Rooty Hill Distribution Centre

Independent Environmental Audit

Report J17175RP1 | Prepared for Holcim (Australia) Pty Ltd | 29 November 2018

Figure 4.1 Figure 5.1 from original Environmental Assessment (National Environmental Consulting Services 2005)

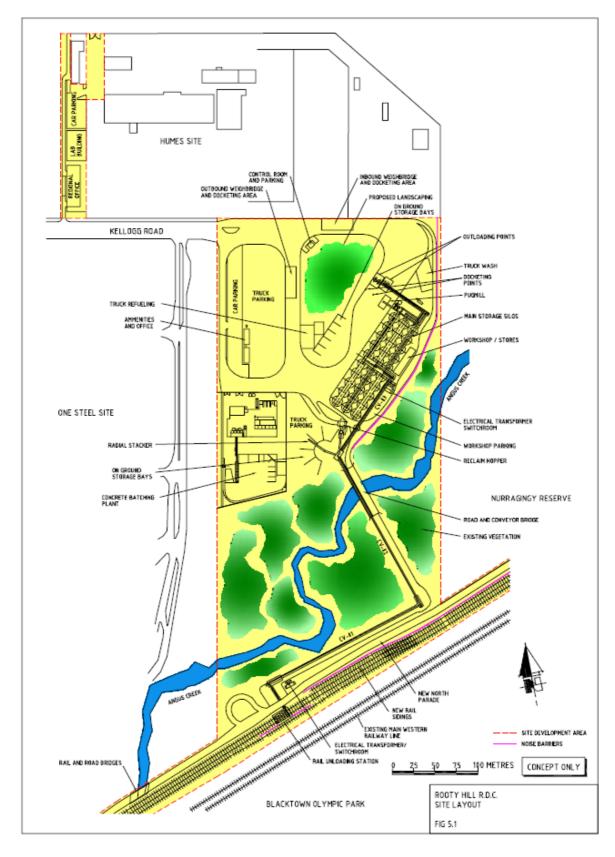
Construction of five ground storage bays each with a capacity of 500 t west of the main stockpiling area. 	 Remove 500 t ground storage bins (as shown in original EA Fig 5.1 [see Figure 4.1 below]). 	No change.	 There are no ground storage bins west of the main stockpiling area.
Rail to storage			
 Use of an above ground conveyor system to transfer materials from the rail 	Materials transferred from the rail unloading facilities to storage bins via an	No change.	Material is transferred from the rail unloading facilities to the radial stacker b

The CBP was constructed during the audit period. There is not a construction certificate or an occupation certificate for the plant. The layout is substantially different from that described in the original EA and this layout has not been changed in subsequent modifications.

Figure 4.2 Figure 5.15 from original Environmental Assessment (National Environmental Consulting Services, 2005)

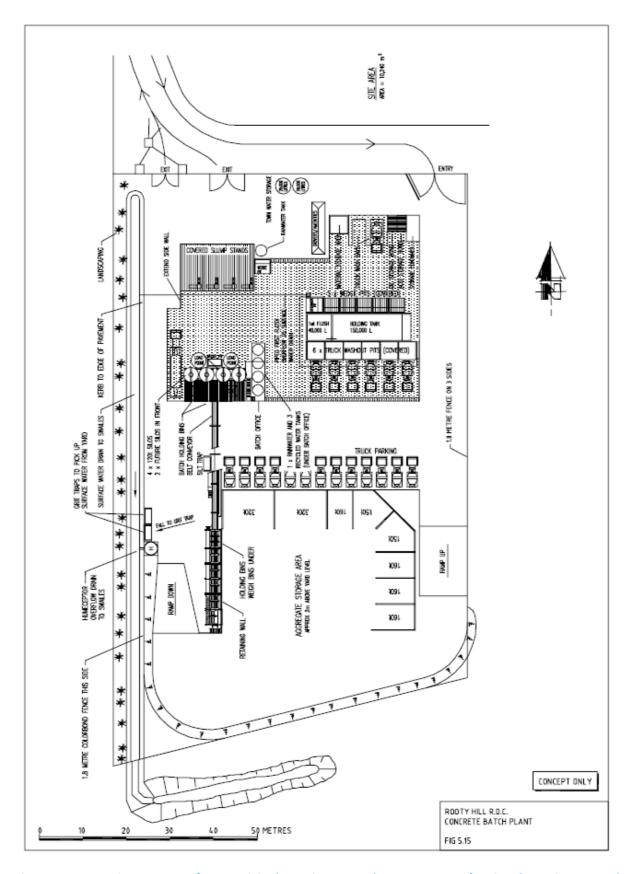
Major Projects Application DA 05_0051	MOD 1	MOD 2	As at site inspection (12 December 2017)	
each containing two truck loading points.	 Removal of reclaim hopper. All material stored in the radial stacker stockpiles would be transferred directly to trucks for distribution via front end loader. 			
	 Minor changes to the conveyor and chute system to reflect the revised project configuration. 			
Concrete batching plant				
 The CBP would have a capacity of 200,000 m³ and would consist of 4 silos (23 m tall) and would store 120 t of product. 	No change.	No change.	 The CBP layout is substantially different from that shown in EA Figure 5.15[see Figure 4.2 below]. 	
 The facility would also include parking for agitators, holding bins, open on ground aggregate storage bins (capacity of 1,740 t), washout pits, truck wash bays, and office and amenity facilities. 				
20 agitator parking bays.				
 Layout provided in EA Figure 5.15 [see Figure 4.2 below].
